**MORRISON-KNUDSEN COMPANY, INC.**

SUBJECT: AFFECT OF LUBE OIL MODIFICATION ON 6 GPM CIRCULATING SYSTEM

SUBJECT: Affect of Lube Oil Modification on 6 gpm  
Circulating System

SYSTEM SCHEMATIC DIAGRAM  
(6913)

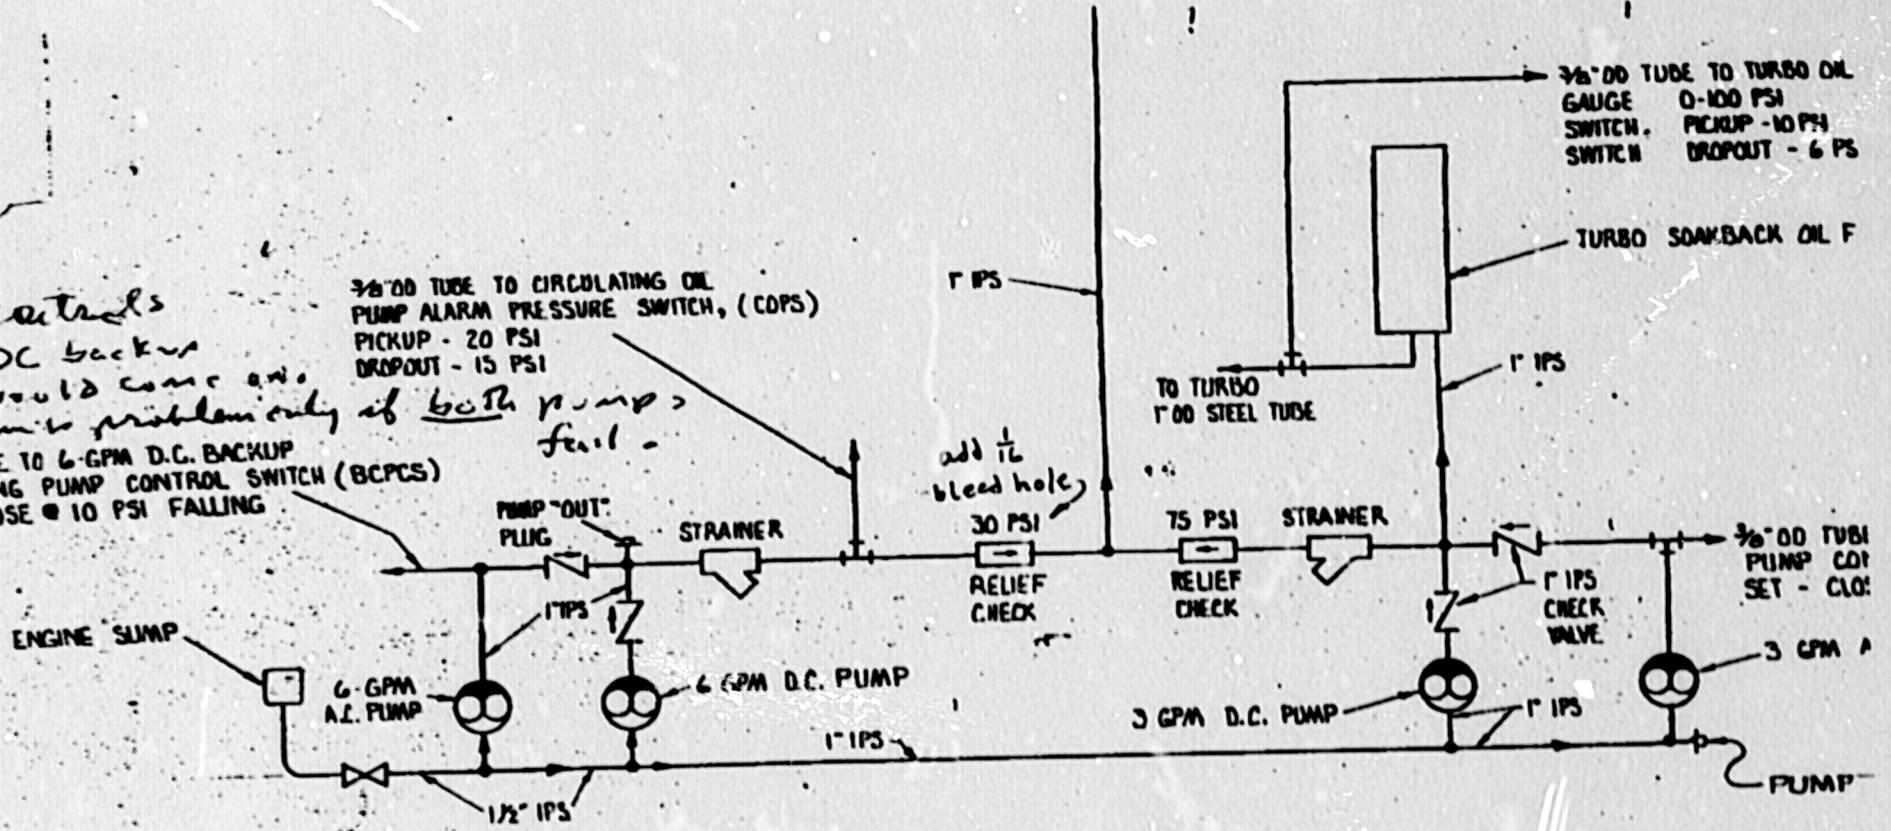
For installations that include a DC motor driven pump in standby to the 6 gpm AC motor driven pump, a check valve is located in the pump discharge line. The installation of the L.O. Modification results in the location of the C.O.P. alarm pressure switch between these check valves and the 30 psi EMD/Kepner "relief check" valve. Pressure is maintained in the line, even in the event of a failure of both pumps, preventing the alarm signal. Prior to the installation of the mod., pressure was relieved through the turbo line.

This controls the DC backup & it would come on alarm to problem only if both pumps fail.

3/8" O.D. TUBE TO CIRCULATING OIL PUMP ALARM PRESSURE SWITCH, (COPS)  
PICKUP - 20 PSI  
DROPOUT - 15 PSI

3/8" O.D. TUBE TO 6-GPM D.C. BACKUP CIRCULATING PUMP CONTROL SWITCH (BCPCS)  
SET - CLOSE @ 10 PSI FALLING

Redundant pumps

To correct the problem at River Bend, GE was provided with a procedure to drill a 1/16 inch hole in 30 psi Kepner "relief check" valve. This procedure is attached. In the event of pump failures, this will allow a sufficient amount of oil to pass to relieve the pressure between the check valves.
